SAN FRANCISCO PLANNING DEPARTMENT

Certificate of Appropriateness Case Report

HEARING DATE: FEBRUARY 18, 2015

Filing Date: October 8, 2014
Case No.: **2014.1422A**
Project Address: **900 NORTH POINT STREET: GHIRARDELLI SQUARE**
Historic Landmark: No. 30 – Ghirardelli Square
Zoning: C-2 (Community Business) District
40-X Height and Bulk District
Waterfront Special Use District, subarea #2
Block/Lot: 0452 / 002
Applicant: Elisa Skaggs
Page & Turnbull, Inc.
417 Montgomery, 8th floor
San Francisco, CA 94104
Staff Contact Pilar LaValley - (415) 575-9084
pilar.lavalley@sfgov.org
Reviewed By Tim Frye – (415) 575-6822
tim.frye@sfgov.org

MUSTARD BUILDING: REPLACEMENT OF STOREFRONTS

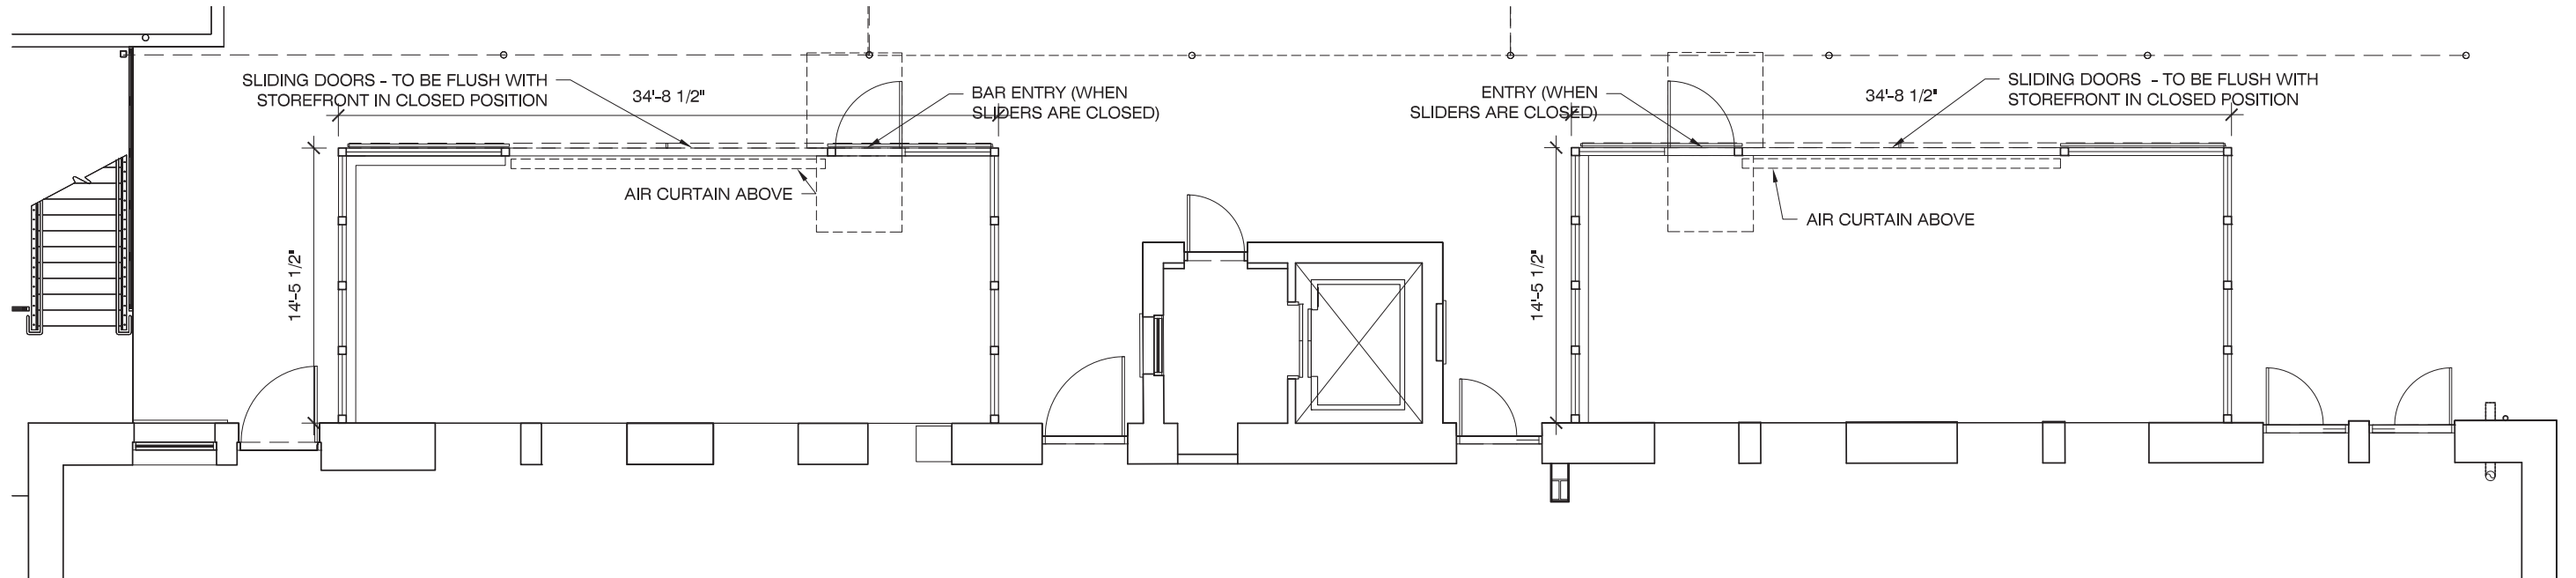
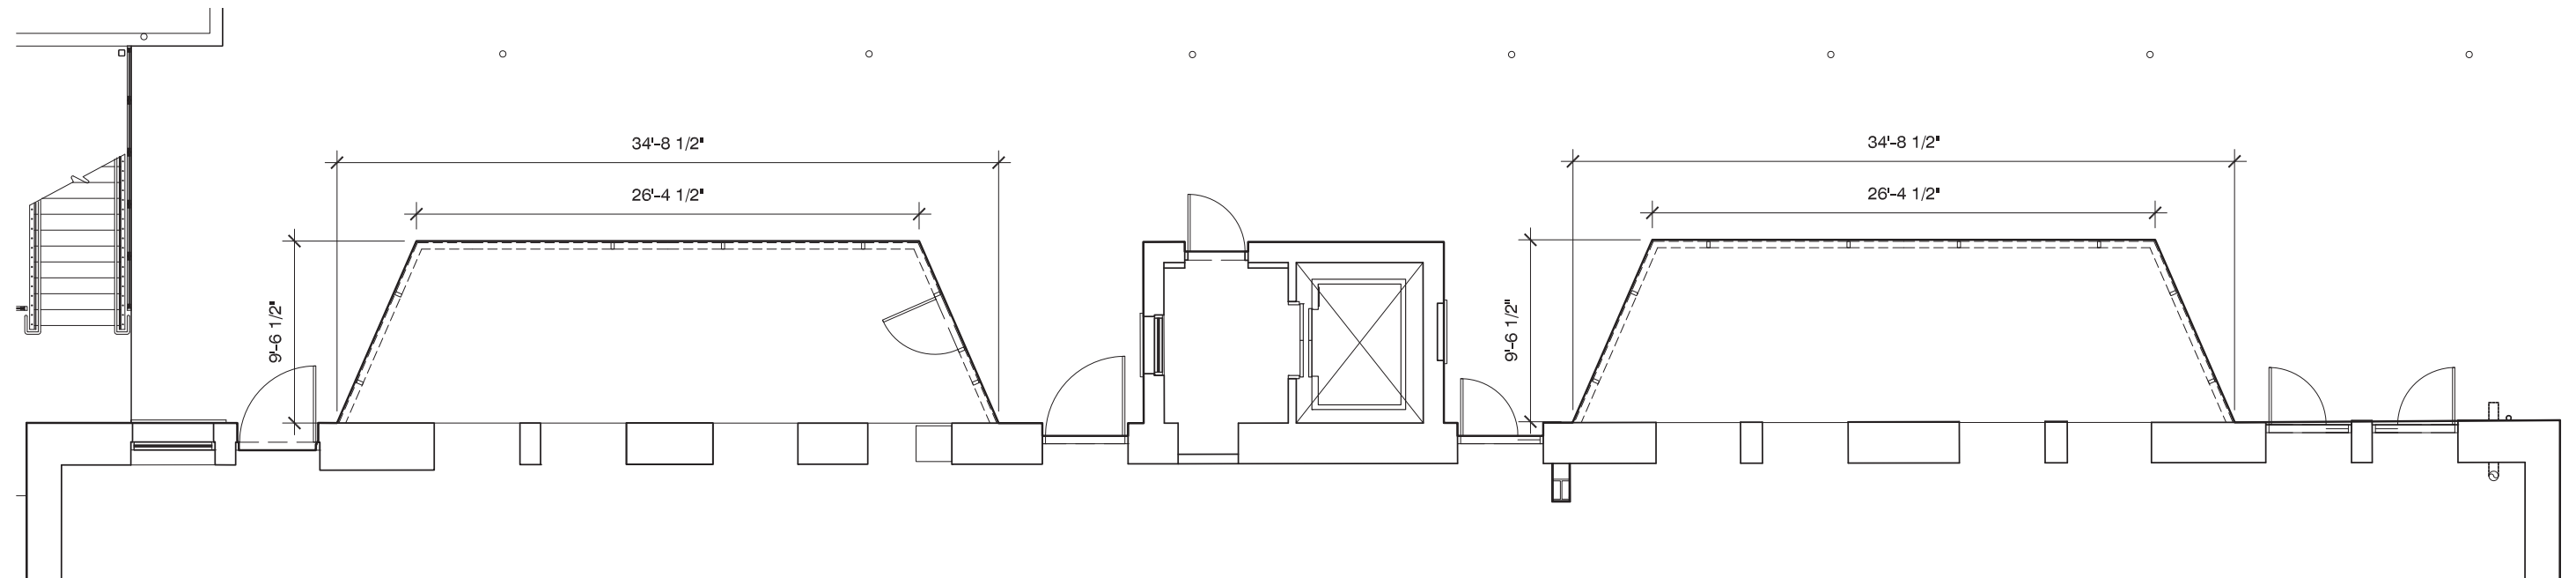
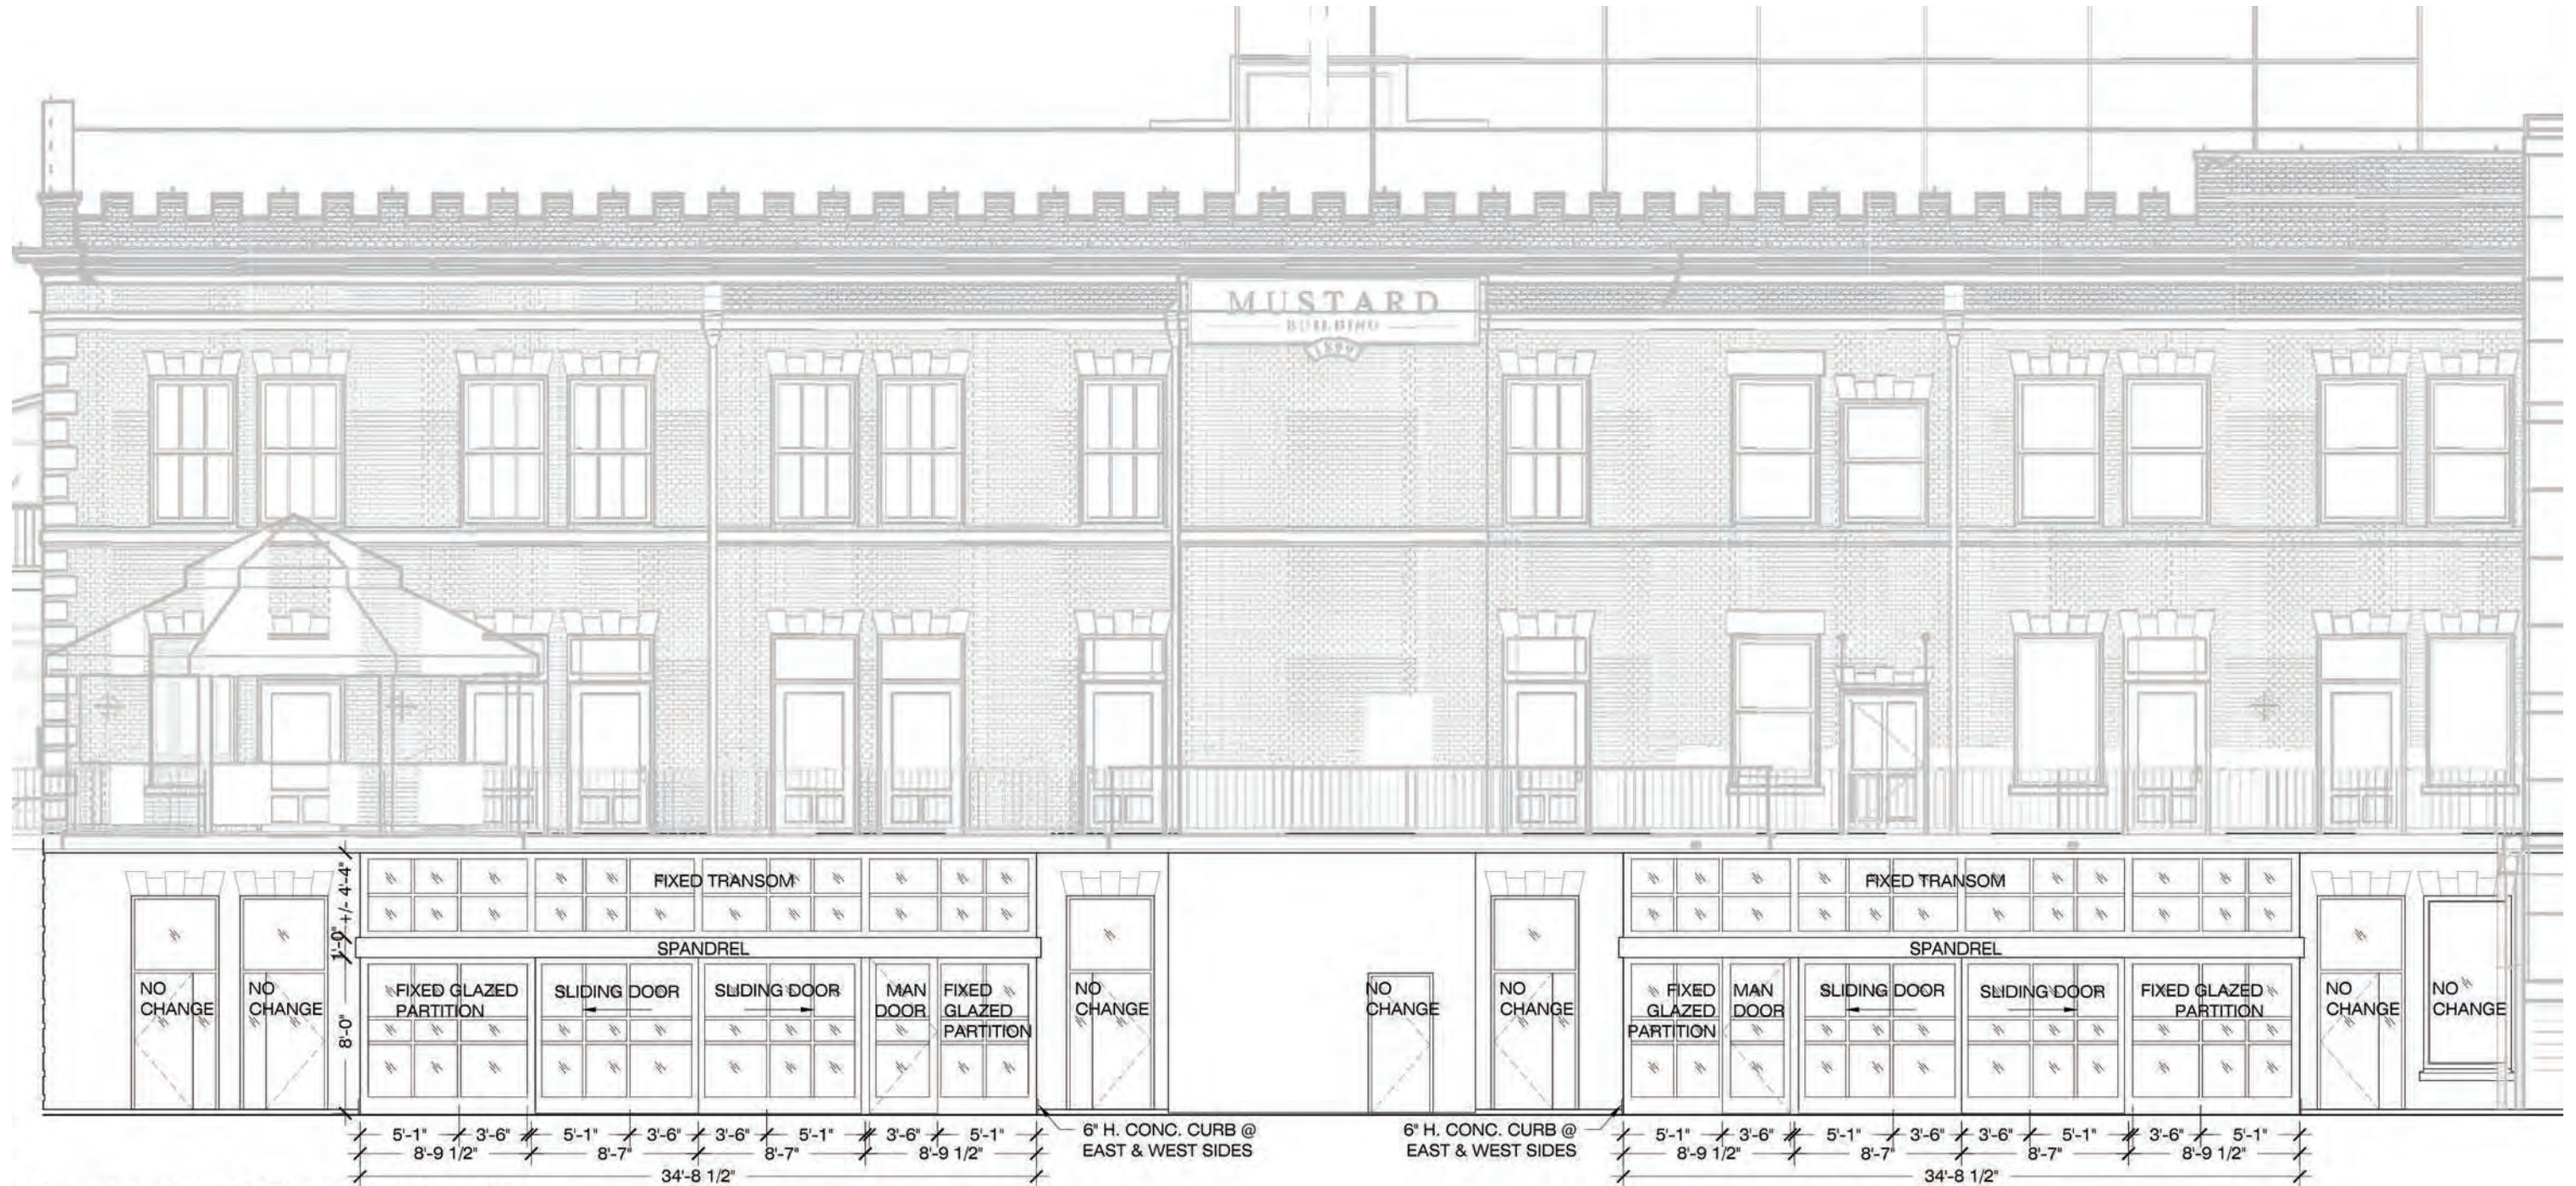
The proposed project will replace non-historic features at the ground floor of the north façade of the Mustard Building and clad the exposed underside of the second floor terrace. Two existing non-historic angled storefront bays that project from ground floor of north façade of Mustard Building. The existing storefront bays appear to date from alterations made in 1984. New storefront will feature operable sash that will slide open to create a large opening in the center of each storefront facing the plaza. When in the closed position, this operable sash will align with the adjacent storefront. The new storefront is proposed as a multi-light metal storefront system with a dark finish. The project also proposes to remove non-historic paint from the brick cladding using the gentlest means possible. No changes would be made to projecting window lintels. The underside of the metal deck would be clad with stucco, which appears to be consistent with the finish for this feature as shown in 1960s-era photographs. Proposed alterations at north façade of Mustard Building appear to be compatible with the character of the building and site in conformance with the *Secretary's Standards* with the following modifications.

7. *Staff recommends provision of product and methodology specifications for proposed paint removal at brick for review and approval by staff.*
8. *Staff recommends preparation of on-site mock-ups for proposed paint removal with review and approval of means and methods by staff.*
9. *Staff recommends that finish and tone for stucco at underside of deck be submitted to staff for review and approval for consistency with appearance of this feature in historic photographs. Staff further recommends provision of a reflected ceiling plan for the underside of the deck in the Building Permit Application plans that include location of proposed recessed lighting and scoring of stucco.*

9. That finish and tone for stucco at underside of deck be submitted to staff for review and approval for consistency with appearance of this feature in historic photographs. Staff further recommends provision of a reflected ceiling plan for the underside of the deck in the Building Permit Application plans that include location of proposed recessed lighting and scoring of stucco.
